Please find attached my letter of submission to DA2024/1427, Alterations and additions to 14 Bareena Drive Balgowlah Heights.

RE: SUBMISSION LETTER TO DA2024/1427 - 14 BAREENA DRIVE BALGOWLAH HEIGHTS

Figure 2 North – South section

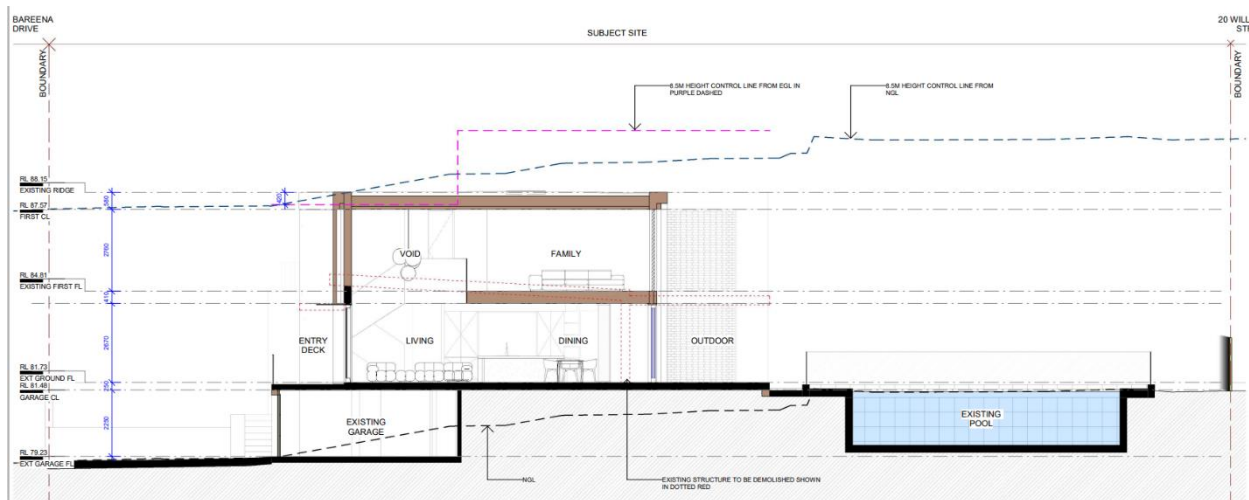
Firstly, it must be noted there are numerous conflicting references to the extent of height breach contained within the applicant's Architectural Drawing submission. Drawing ref A401- Section AA of the Architectural Documentation notes a 420mm exceedance (Figure 2), whereas Drawing ref A704 3D Height Plane Diagram (contained within the same drawing package) reference an exceedance of 440mm (Figure 3). Both references are taken from existing ground level at RL 79.23 to the proposed ridge line at RL 88.15 (ie 420mm exceedance). The Architectural Documentation must be amended to be consistent in the extent of height breach at 420mm.

Additionally, and importantly, there are errors in the calculation of the height breach as reported within BMA Urban's Clause 4.6 Variation Request. BMA Urban have incorrectly calculated the extent of the height breach under Section 2.2 of their paper, stating the departure measures 440mm or 5.1% against the Development Standard. BMA Urban have measured from the *top* of the existing ground floor slab at RL 79.23, whereas the correct level should be taken from the *underside* of the existing ground floor slab, which assuming a 300mm concrete slab, would be RL 78.93.

Acknowledging the above, and the correct and lawful RL to which the 8.5m height breach is calculated from (RL 78.93), the height exceedance of the current building form is 720mm (being the current proposed 420mm exceedance plus an additional 300mm, being the *underside* of the existing ground floor). The revised 720mm exceedance in height control equates to 8.5%.

1. Lower the Northern parapet of the proposed building within the MLEP controls of 8.5m, when measured from the underside of the existing ground floor slab;

Figure 4 Overshadowing diagram – 9am Winter Solstice

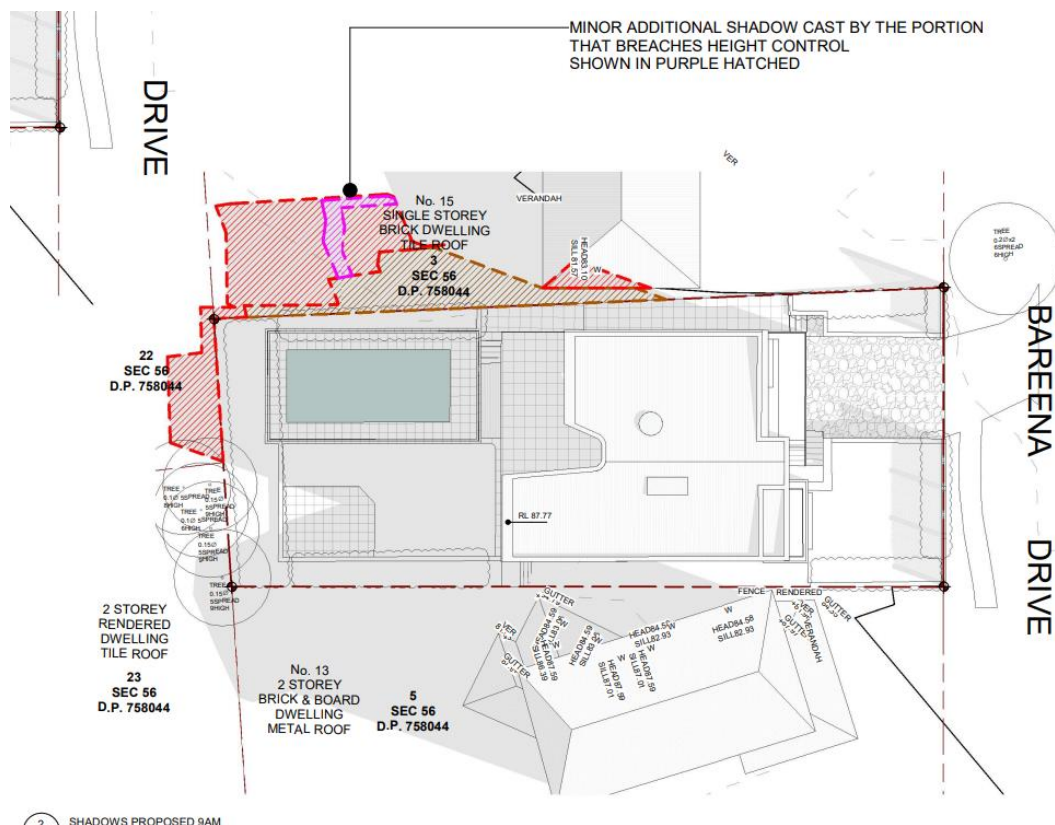
Figure 4 below is an extract of the shadow diagram contained within Hass Studios architectural package lodged with the application. The diagram demonstrates the existing and additional loss of solar amenity as a result of the proposed building mass at 9am during the Winter Solstice. The additional red hatched section noted on the diagram as ‘minor additional shadow cast by the portion that breaches height control’ equates to over 100% loss in solar amenity to my private open space.

The additional building height therefore adversely impacts solar access to my private open space and consequently contravenes planning objective (d) under Clause 4.3(a) of the MLEP. Not only is solar access is *not* maintained to my private open space, it is significantly reduced as a direct consequence of the contravention in building height standards.

Figure 7 – Proposed ground floor

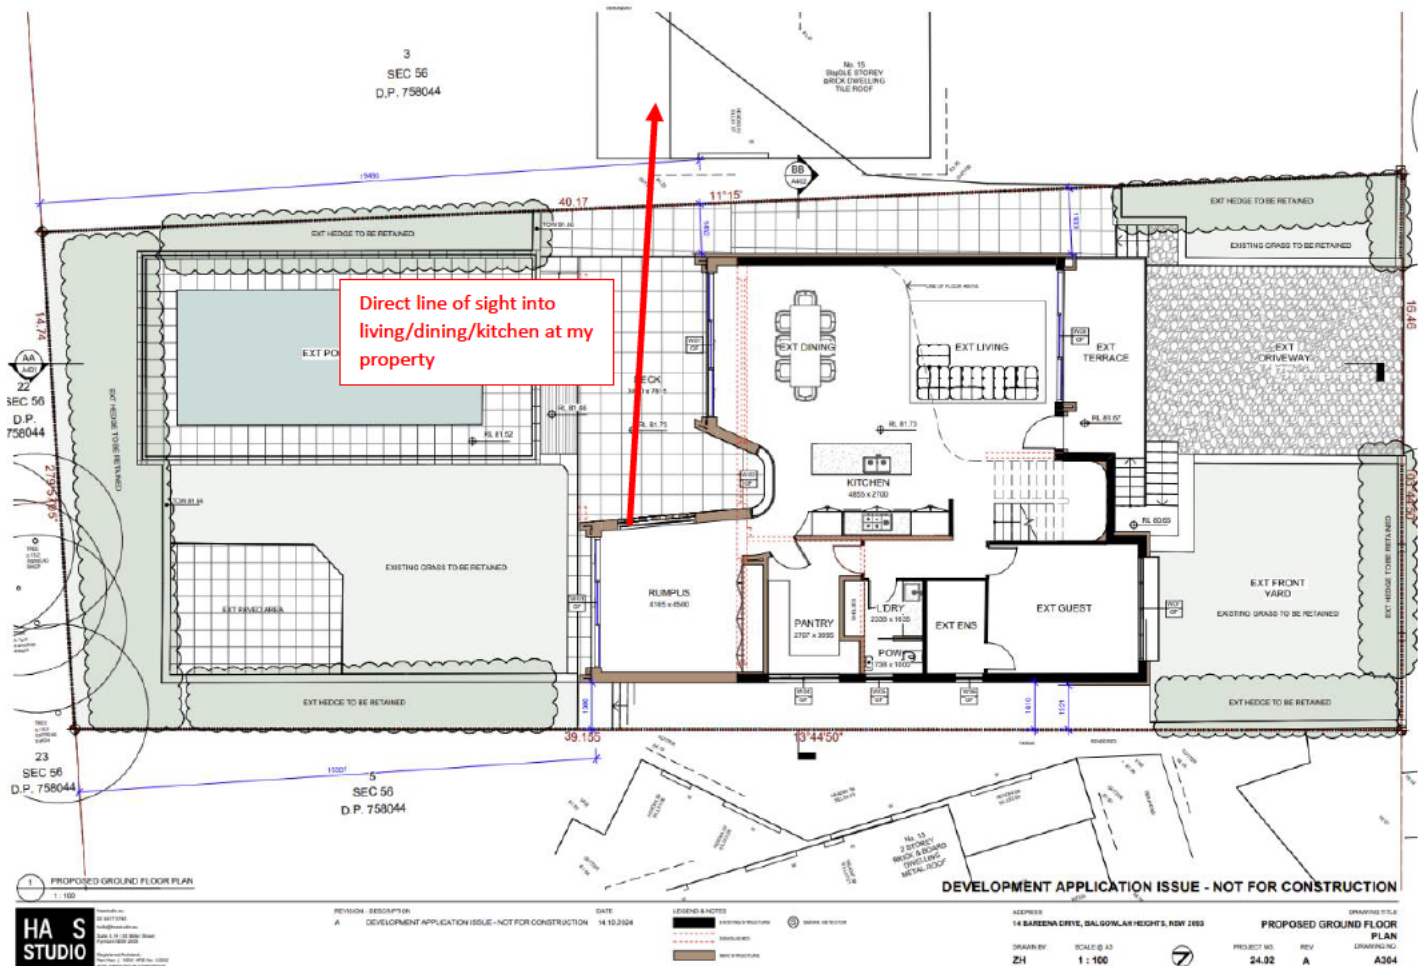
The rear addition of the Rumpus room on the Southern elevation of the ground floor is concerning as it introduces a direct line of sight into my living, dining, and kitchen rooms, as well as my Southern terrace private open space, as notated in Figure 7. This line of sight into my habitable area & private open space (as defined under the MDCP) is a breach of Privacy under Clause 3.4.2 of the MDCP, contravening the following planning objective:

4. Include rumpus room Western window in documented window schedule to determine appropriateness of proposed size and extend of glazing;
5. Significantly reduce the extent & type of glazing (ie opaque) to rumpus room window, W09 & W12 to address overlooking into private open space and habitable space from both my property and neighbouring properties,

6. Introduce external privacy screens to rumpus room window (to be scheduled), W09 & W12 to address overlooking into both private open space and habitable space from my property and neighbouring properties,

Figure 8 – Proposed first floor

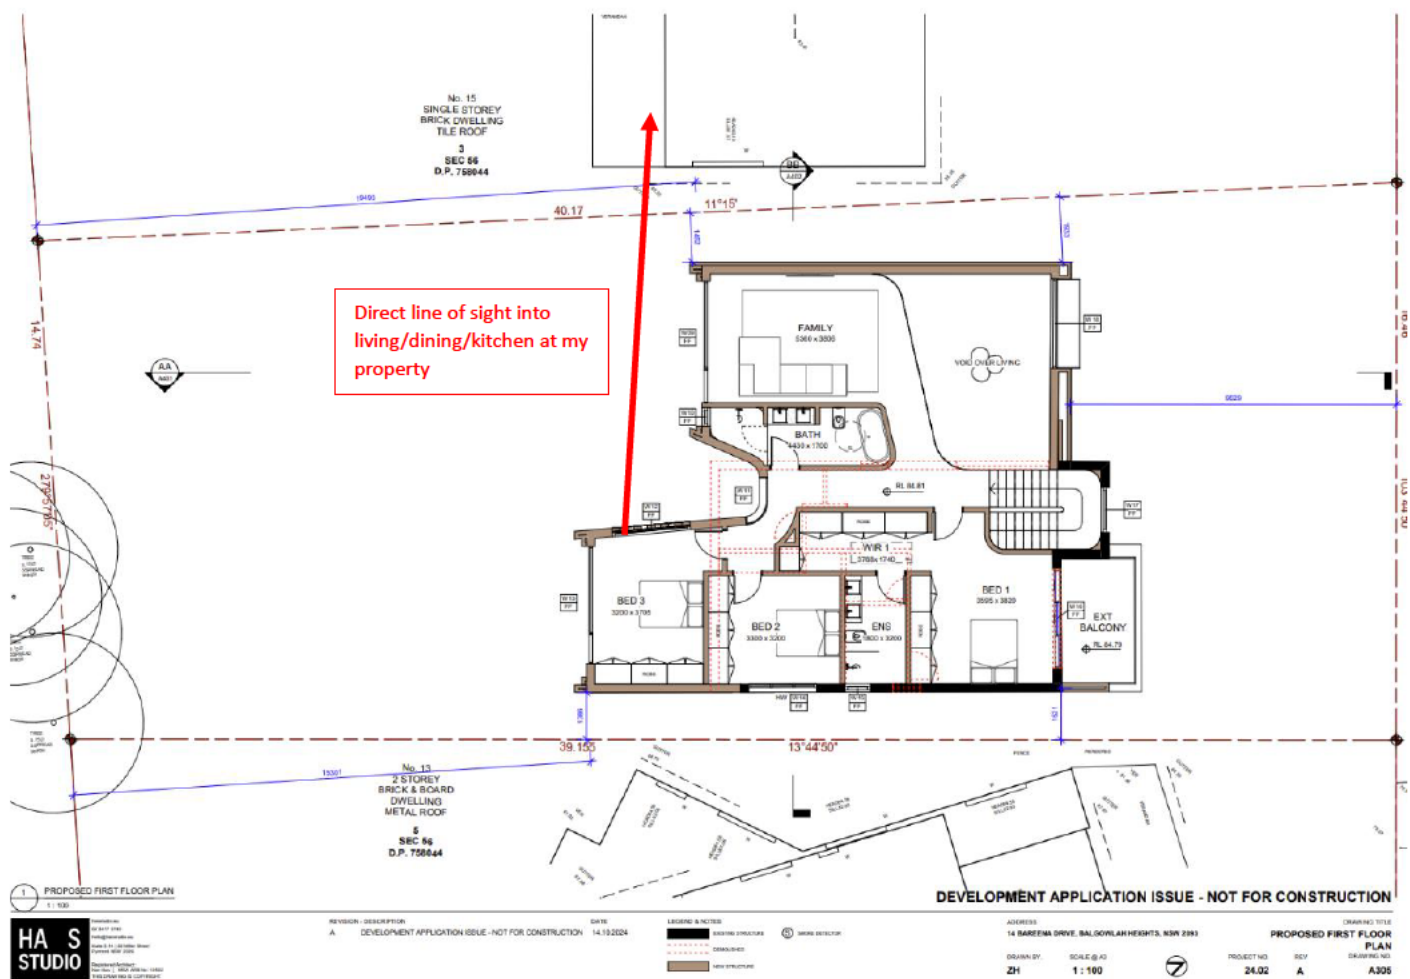
Likewise, proposed window W12 of the new bedroom 3 introduces a direct line of sight into my living, dining, and kitchen rooms, as notated in Figure 8. This line of sight into my habitable area & private open space (as defined under the MDCP) is a breach of Privacy under Clause 3.4.2 of the MDCP for the same reasons as mentioned above.

Figure 9 Proposed rumpus room Western window (undocumented window)

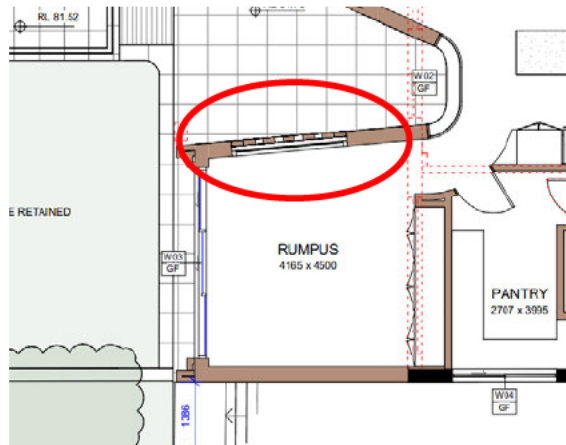
Additionally, the proposed Western window of the rear Rumpus room is not contained within the Window Schedule of Hass Studios architectural package lodged with the DA submission. Figure 9 below notates the lack of window identification on plan. The proposed window dimensions, and extent of glazing, that introduces the line of sight into my habitable area & private open space, is therefore unknown & cannot be assessed against the Clause 3.4.2 Privacy and Security of the MDCP.

Figure 11 Lines of sight into private open space caused by W09

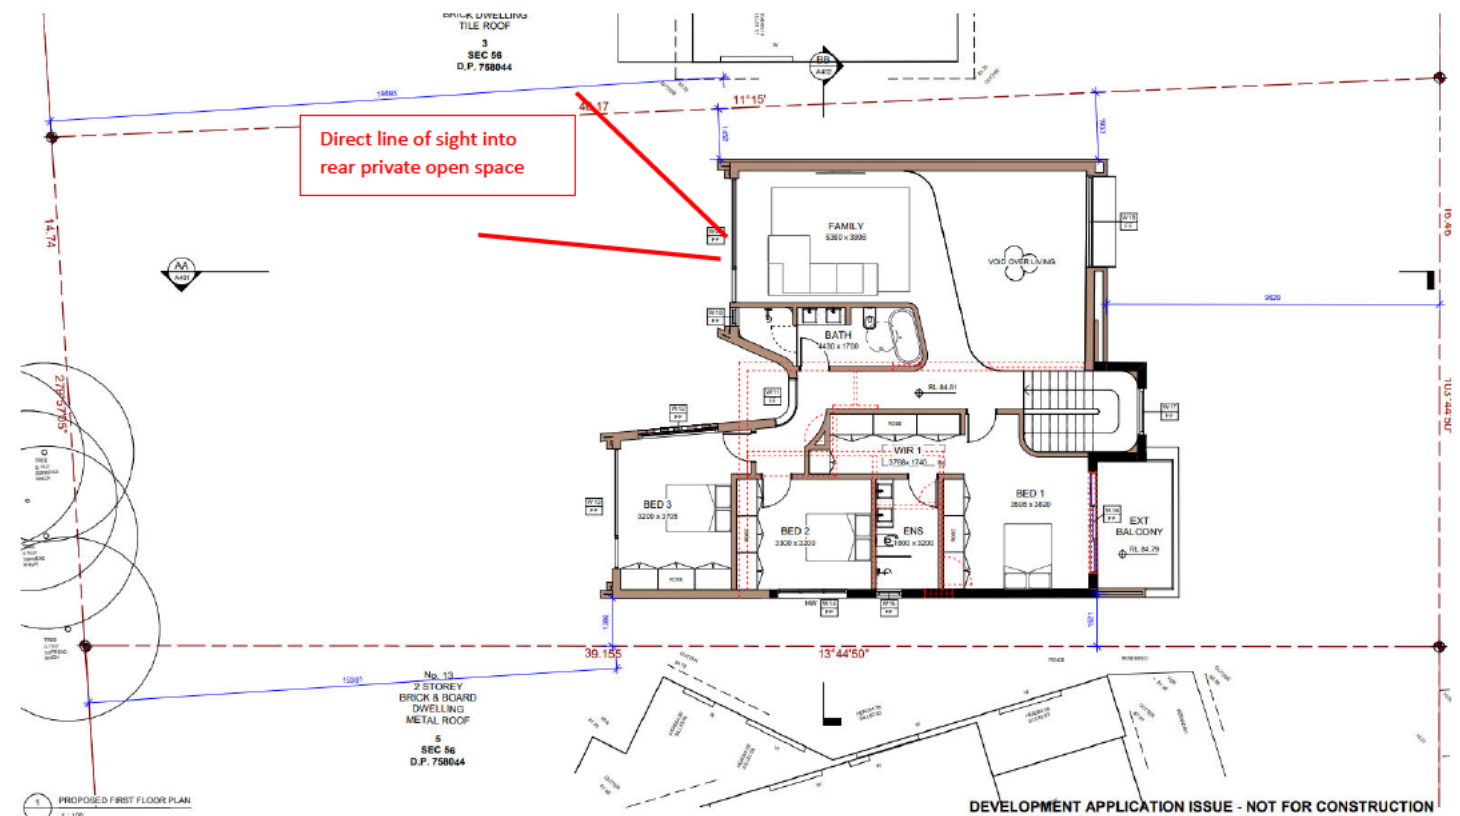
Figure 11 below demonstrates the line of sight onto my private open space, when stood in the proposed family room on the first floor. I fiercely oppose the introduction of a primary living space overlooking my private open space. The expanse of the proposed full height, full width window W09 (3.6m wide x 2.7m high) as identified above in Figure 10, is extremely inappropriate in this setting and context.

Figure 12 Reconfiguring first floor plate to address overlooking concerns from neighbours

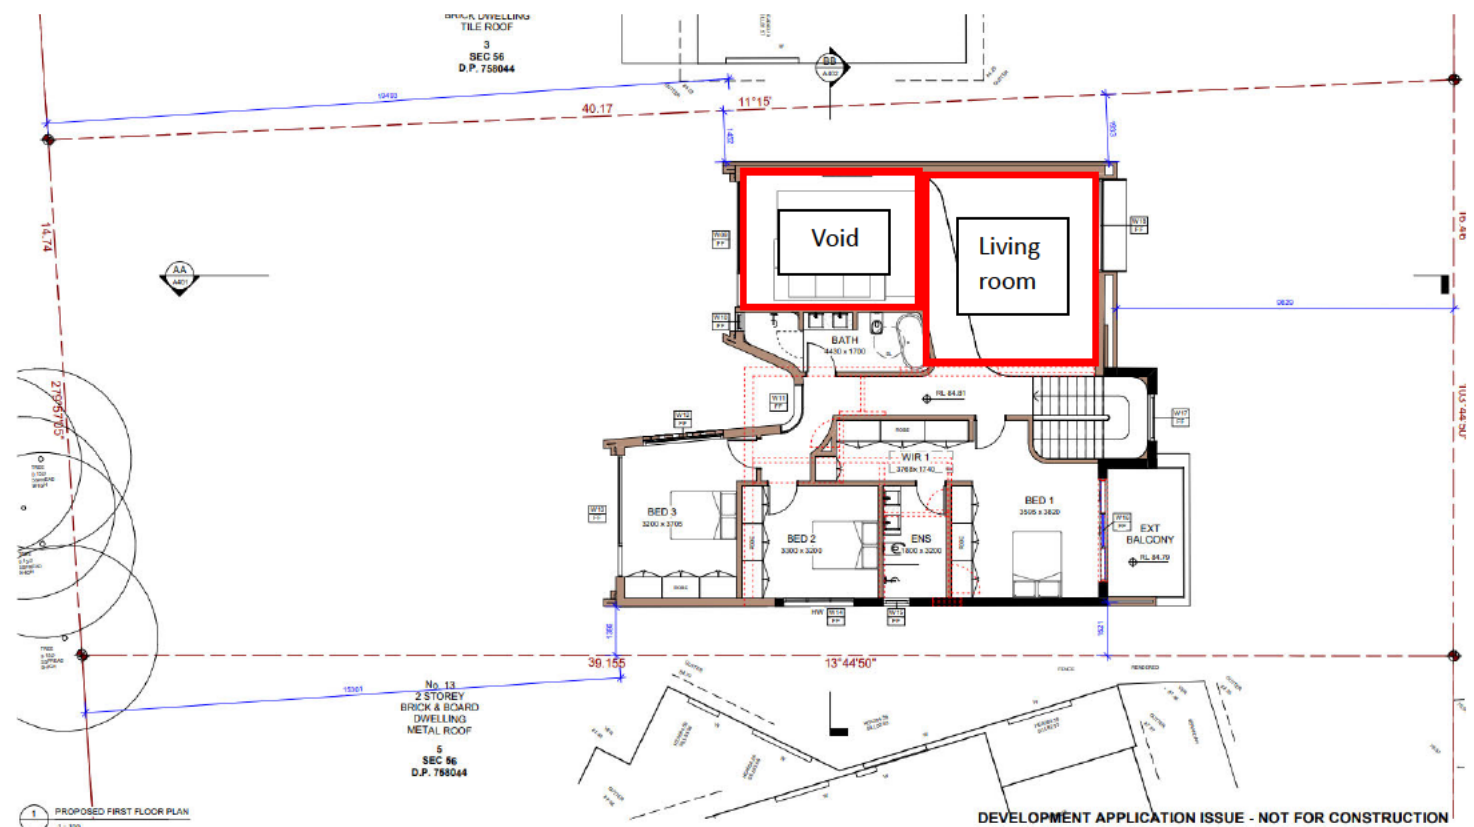
Figure 12 below demonstrates diagrammatically the recommended design solution discussed at this meeting. The proposed relocation of the living space to the North provides a better design outcome, in terms of natural light, views, ventilation from prevailing wind direction, and addresses our shared concerns of overlooking.

7. Reconfigure Western portion of the proposed first floor so the living space is facing the North and void is facing the South.
